Development Application **ACCESS REPORT**

Reference Number: 24216

Site Address: 465-469 Princess Highway & 5-7
Geeves Avenue, Rockdale, NSW 2216

This Access Compliance Report is to accompany a Development Application (DA) for the development proposed at **465-469 Princess Highway & 5-7 Geeves Avenue, Rockdale, NSW 2216**

L1-U7

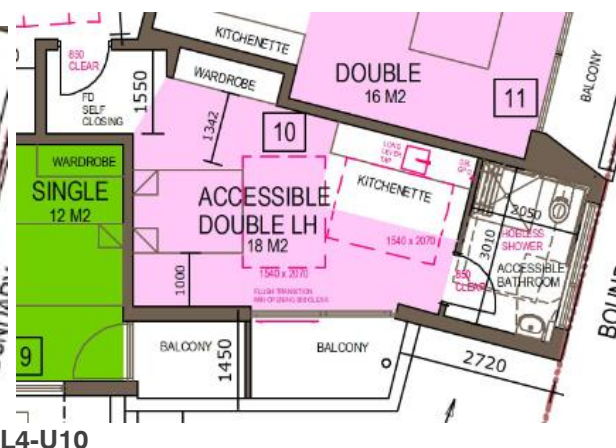
General comment: All sliding doors to the balconies of the accessible units are required to provide for clear door circulation spaces as shown in the options below

All doors including entry door to provide 850mm clear opening space with the necessary door circulation spaces and fixtures as specified under AS1428.1
